RISO, INC. **PARTS CHANGE INFORMATION**

PART: SEPARATOR LEVER AND SHAFT **ISSUE #: 069**

NEW PART NUMBER:011-13301-208, 011-13304-100 NEW DESCRIPTION: SEPARATOR LEVER, SEPARATOR SHAFT OLD PART NUMBER: 011-13301-100, 011-13304-002 OLD DESCRIPTION: SEPARATOR LEVER, SEPARATOR SHAFT	[ ] New [X] Modified [ ] Obsolete [ ] Other
Compatible: [ ] Not Compatible: [X] Old/Obsolete: [ ]

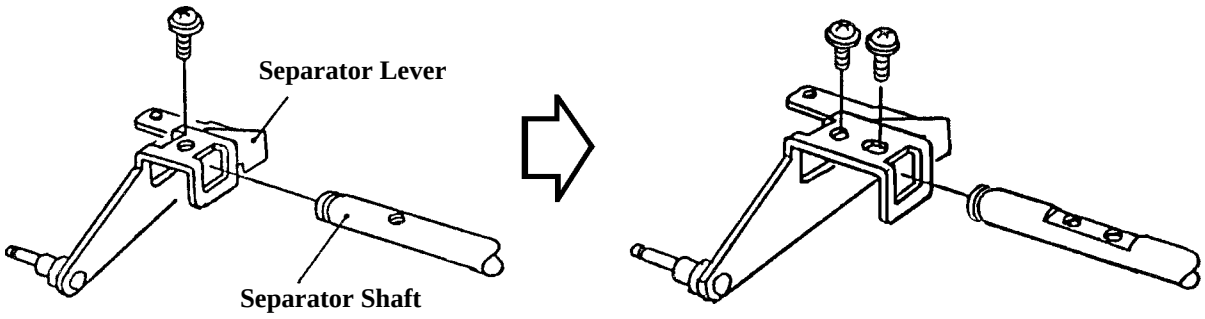
1. The Separator Lever has been reformed to include another screw hole.
2. Another screw hole has been added to the Shaft to secure the Lever.
3. The surface of the Shaft has been cut in a “D” shape to secure the lever.

1. To prevent the deformation of the Separator Lever.
2. To attach the Separator Lever to the Separator Shaft more securely.

When replacing the existing Separator lever with the modified one, replace the existing Separator Shaft at the same time, or vice versa.
